ENGINEERING CHANGE NOTICE NO.

05397

DWG NO. 647.7700

DWG TITLE: STRUT ASSY

SHEET 2, ZONE D4 IS:

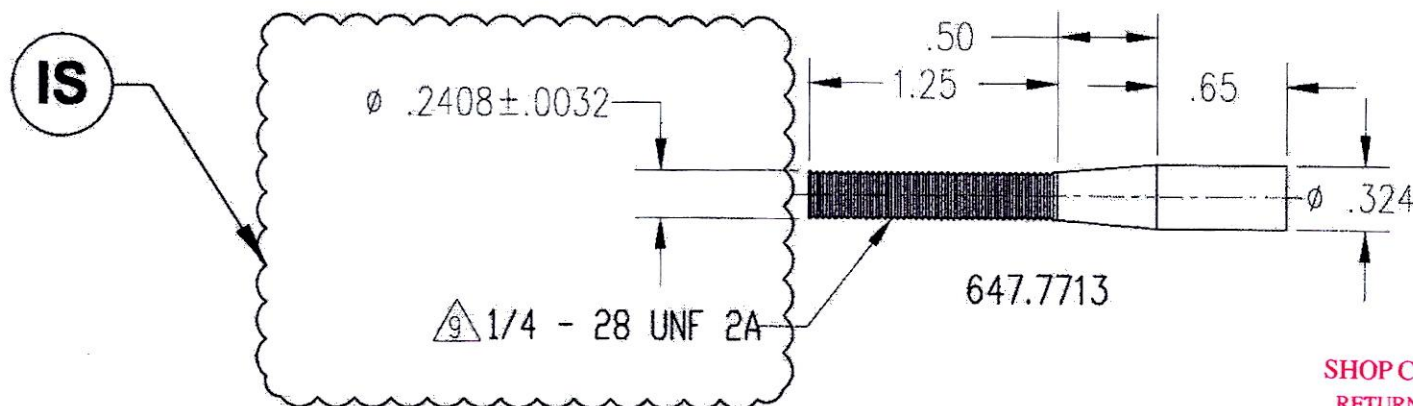
REASON: REVISED DIMENSION
